07-486r0 SAS-2 Receiver Device Physical Testing

Subject: 07-486r0 SAS-2 Receiver Device Physical Testing

Replace section 5.3.7.4.4 with this text.

Figure 126 -- SAS-2 Stressed Receiver Sensitivity Test Block Diagram

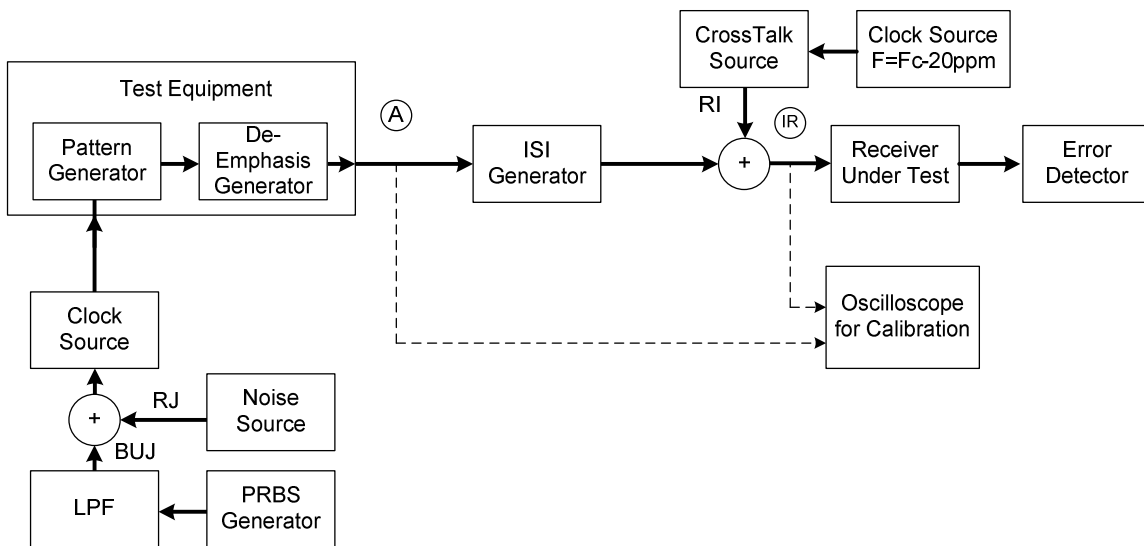
The following test shall be applied at the receiver device compliance point (IR or CR) as a means to perform physical validation of predicted performance of the receiver. Figure 126 shows the block diagram of the stressed receiver sensitivity test.

The design under test will demonstrate its ability to compensate for channel Inter Symbol Interference (ISI) representative of the SAS-2 reference channel while subjected to the budgeted jitter and cross talk sources.

As illustrated in the Figure 126, test equipment is used to generate a representative transmitted waveform (A) with the electrical characteristics of Table 73.

The transmit launch signal is established at point A in Figure 126 per the electrical parameters of Table 73 using test equipment. Waveform calibrations are per references in Table 73.

Figure 127 -- SAS-2 Reference Channel Differential Insertion Loss

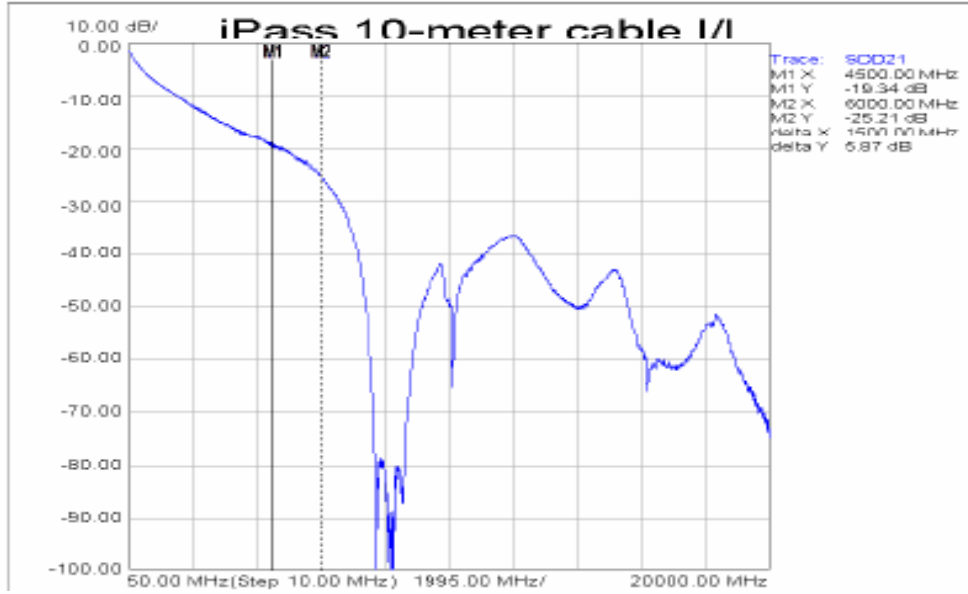
Per T10-07-193 the SAS-2 reference channel's differential insertion loss is illustrated below and leads to a nominal ISI generators insertion loss requirement of -15dB at Fbaud/2. The insertion loss is measured by observing the delivered eye at CR and IR per the specification in Table 73. This is calibration is illustrated in Figure 128.

Figure 129 -- Reference Channel Delivered Pulse Response

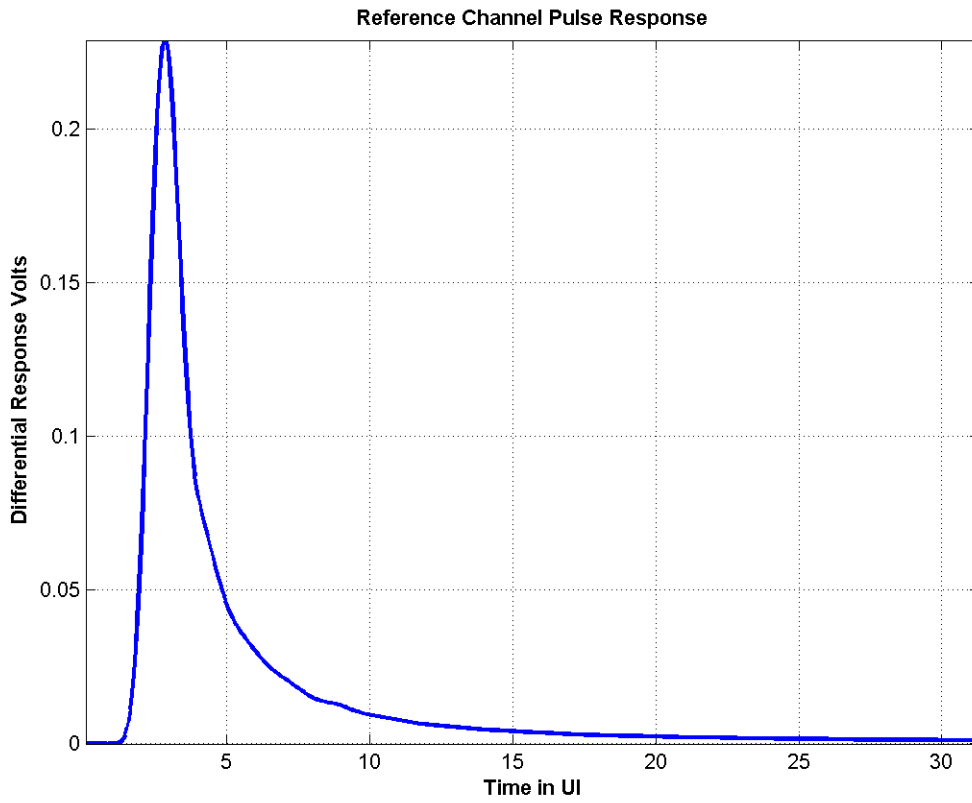
A representative delivered pulse response for this channel when driven with a transmit source (per Table 73) is illustrated in Figure 129 and Table 74.

Figure 130 -- Jitter Tolerance Test Configuration

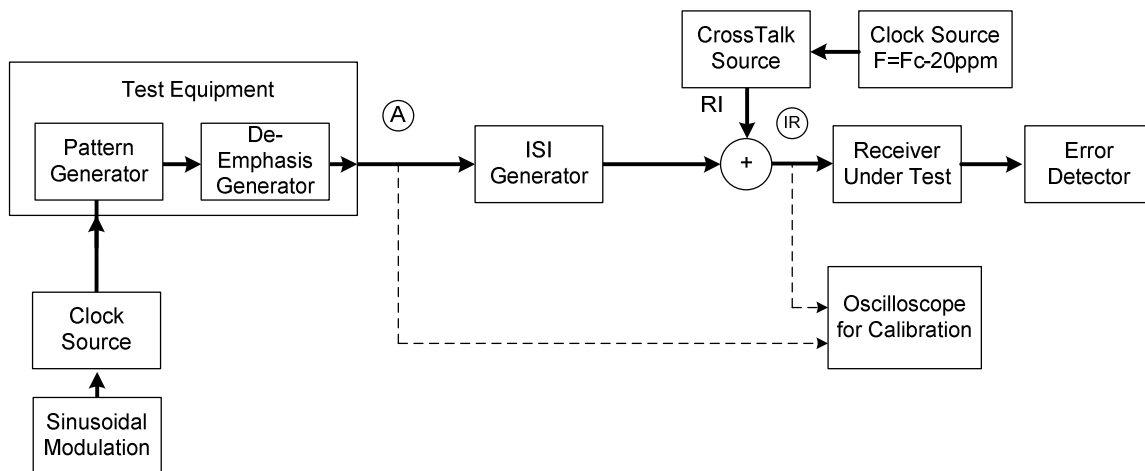
A compliant SAS-2 receiver shall satisfy the Jitter tolerance test described in this section. The jitter tolerance test leverages the receiver device physical test hardware. The receiver under test must demonstrate a BER of better than $1e-12$ with a 95% confidence level when subjected to the sinusoidal jitter of Figure 117. The Jitter tolerance test uses the electrical characteristics of Table 73 with the Transmitter RJ and BUJ jitter minimized.
